WAIMAKARIRI DISTRICT PLAN

COUNCIL PLAN CHANGE PC40

PARKING

DECISION

Figure 30.7: Parking Space and Manoeuvring Dimensions

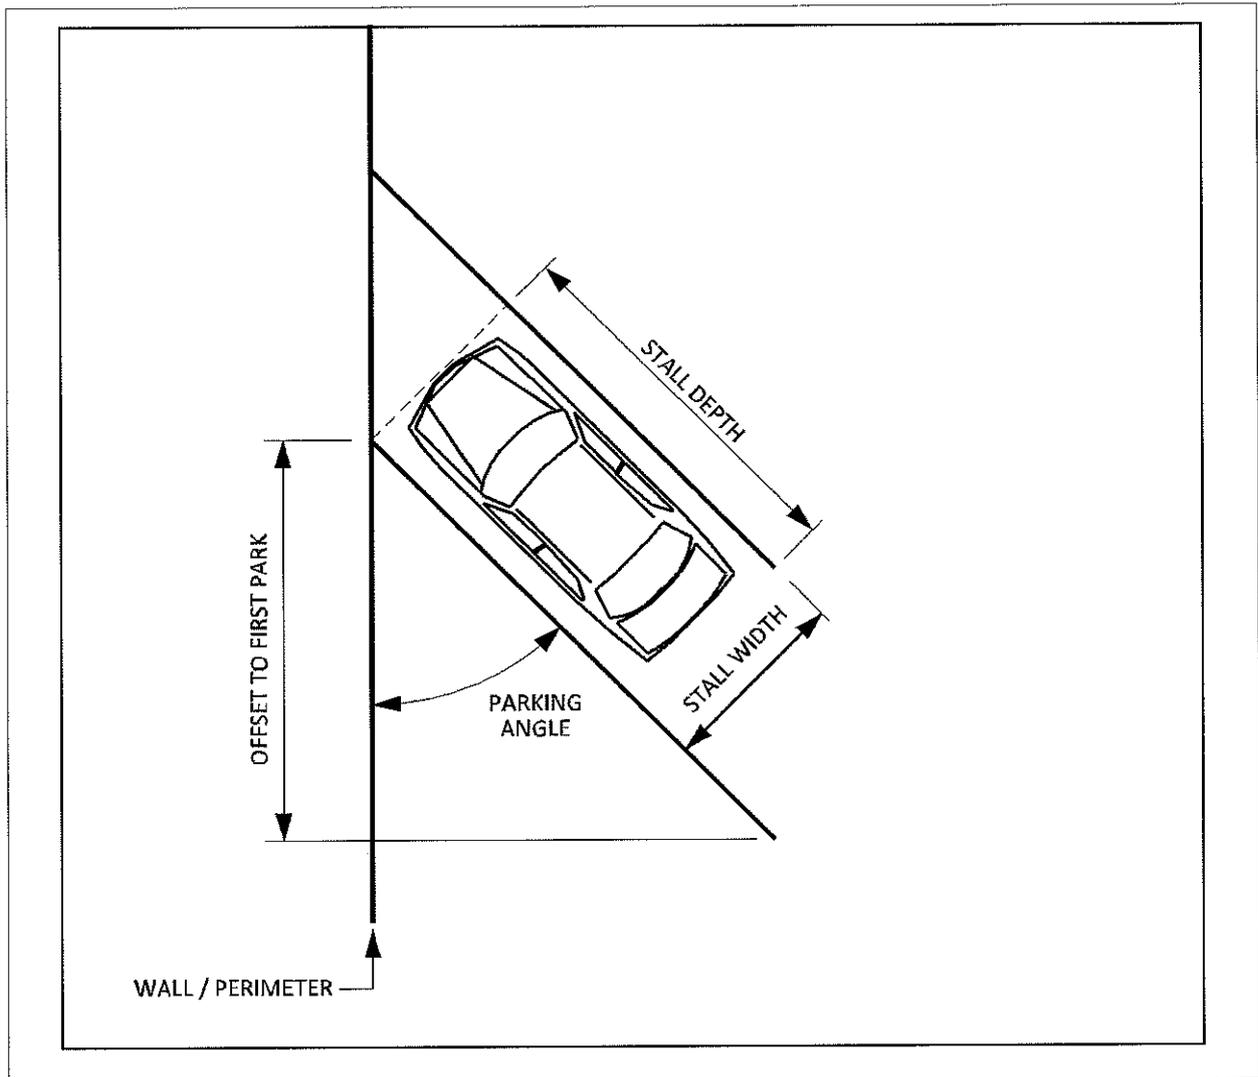
85.18 <i>F90.34</i>	We have provided the revision sought by the submitter of Figure 30.7. This will assist in the effective implementation of the provisions.

Figure 30.8: Turning area for Small Rigid Trucks (7.1m Turning Radius)

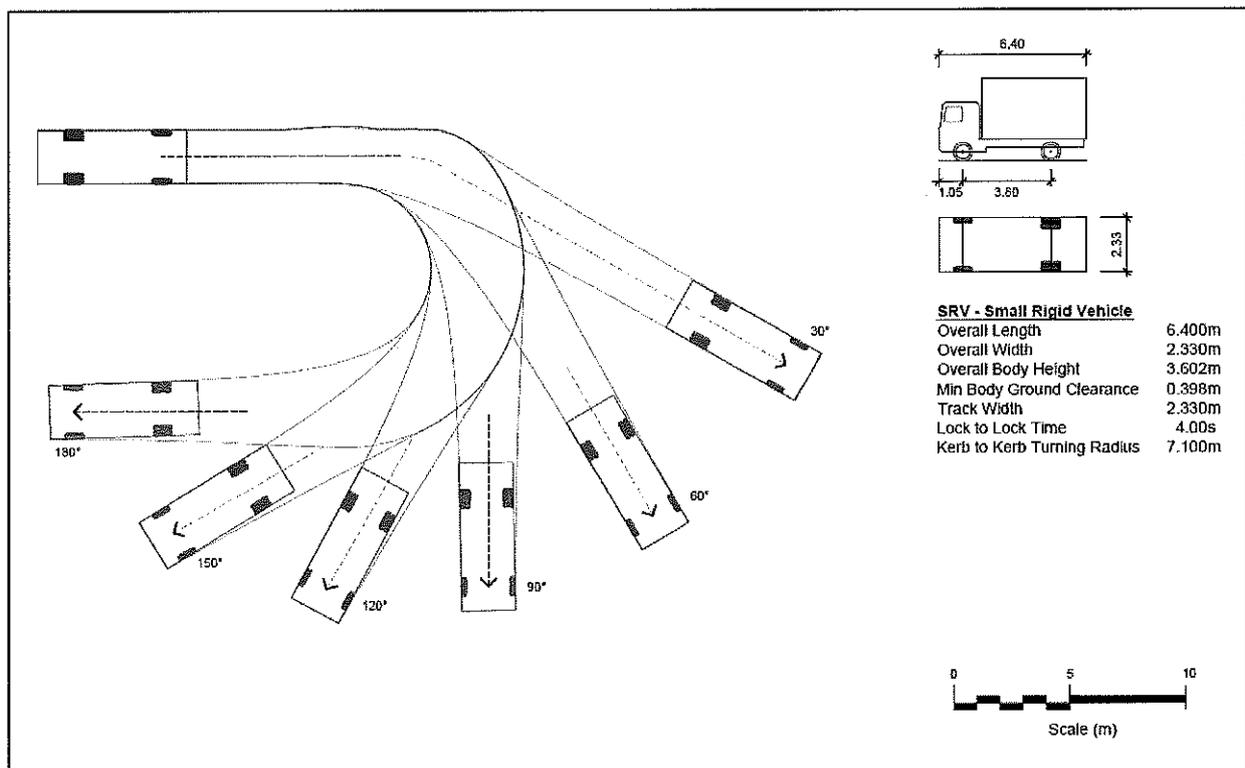
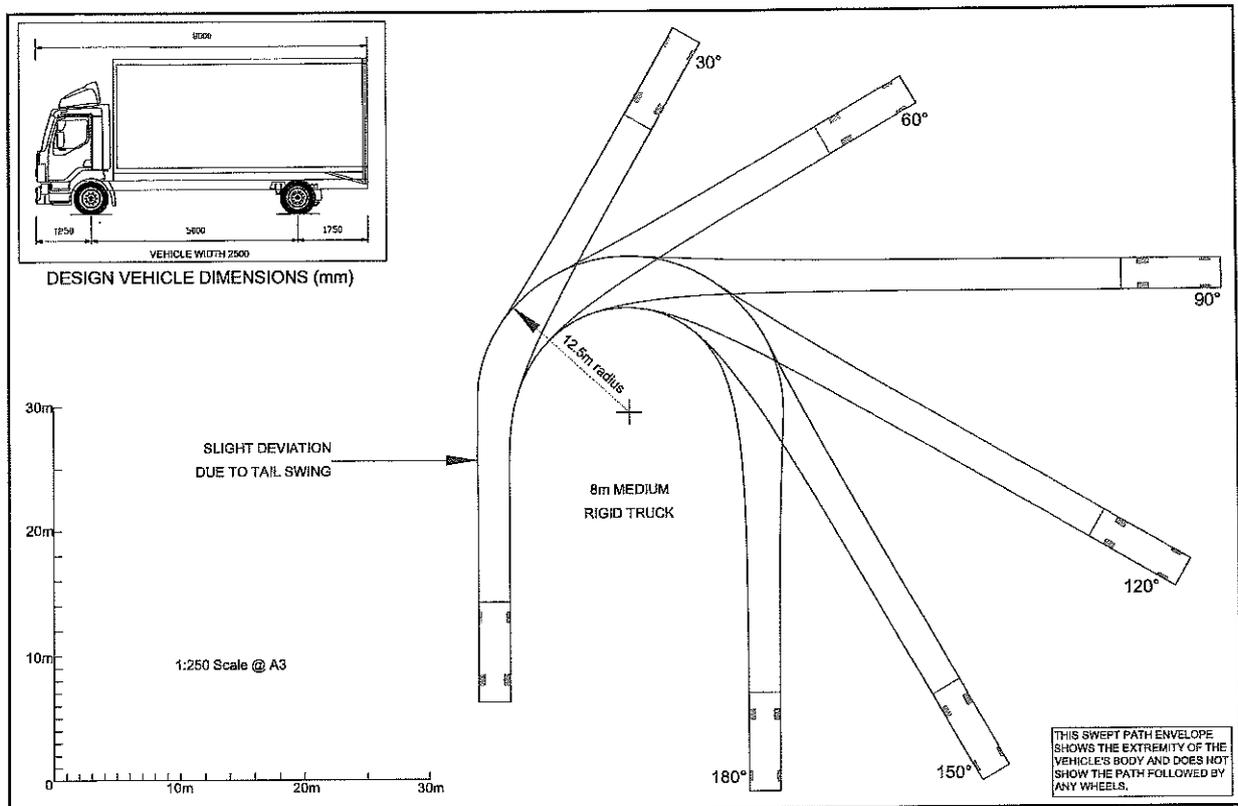
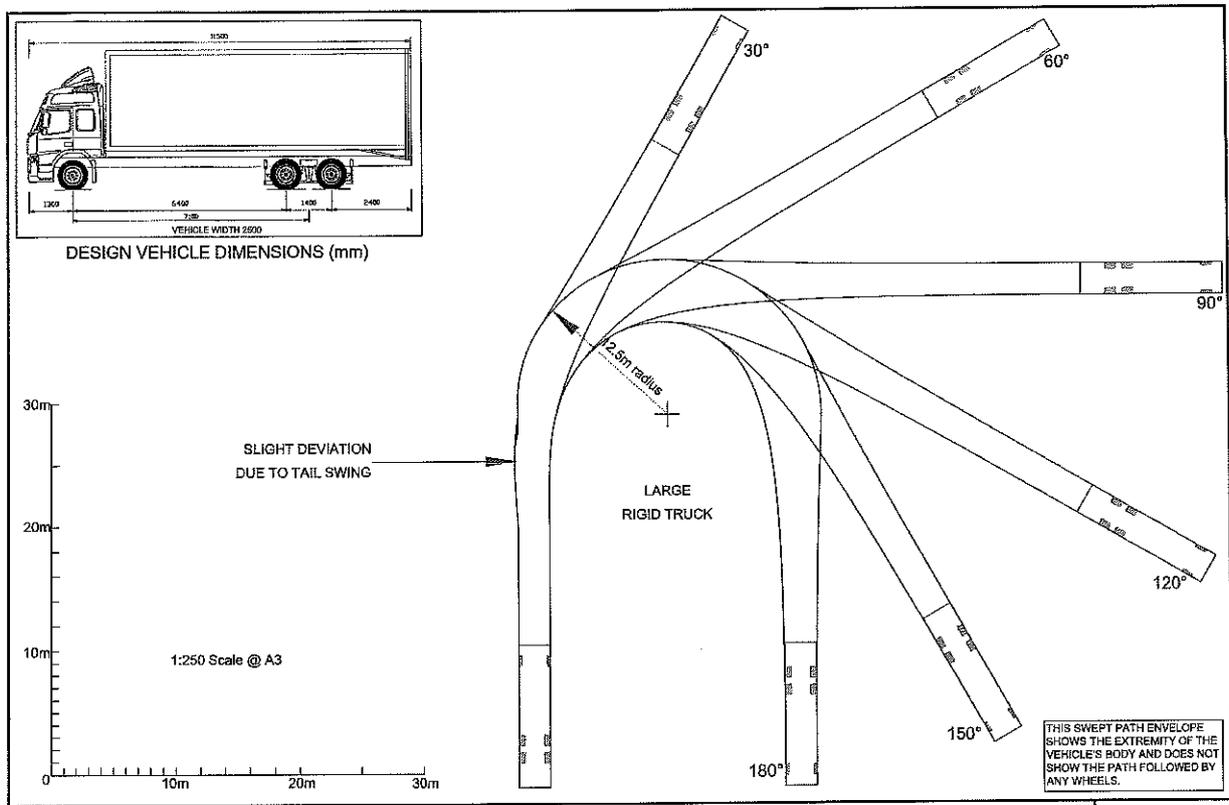
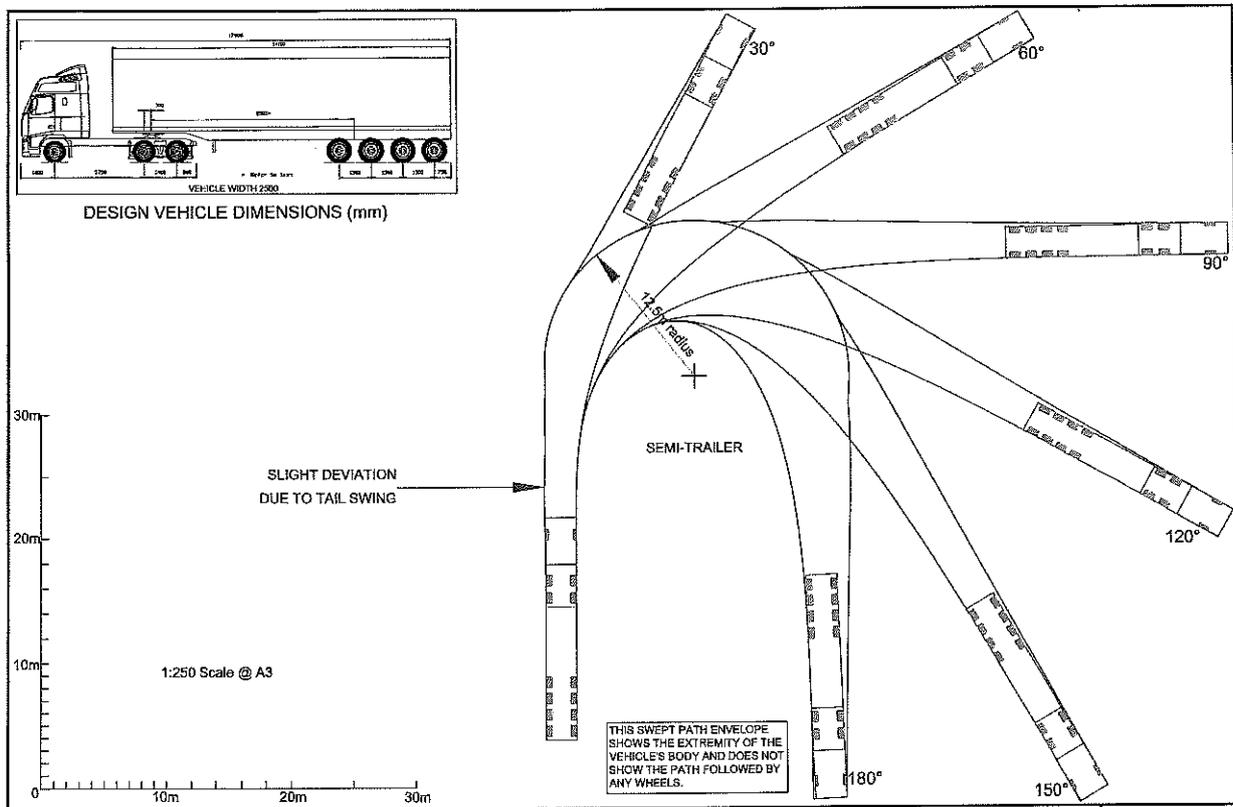
91.15	Accept in Part		The submission sought to delete the reference to a New Zealand Transport Agency tracking curve standard from Table 30.10 auto include the appropriate diagrams in the District Plan. We recognise and incorporate any diagrams for truck tracking curve is would assist in the implementation of the provisions. We do recognise that references may also be incorporated where these are referenced appropriately but consider in these circumstances additional focus should be added.
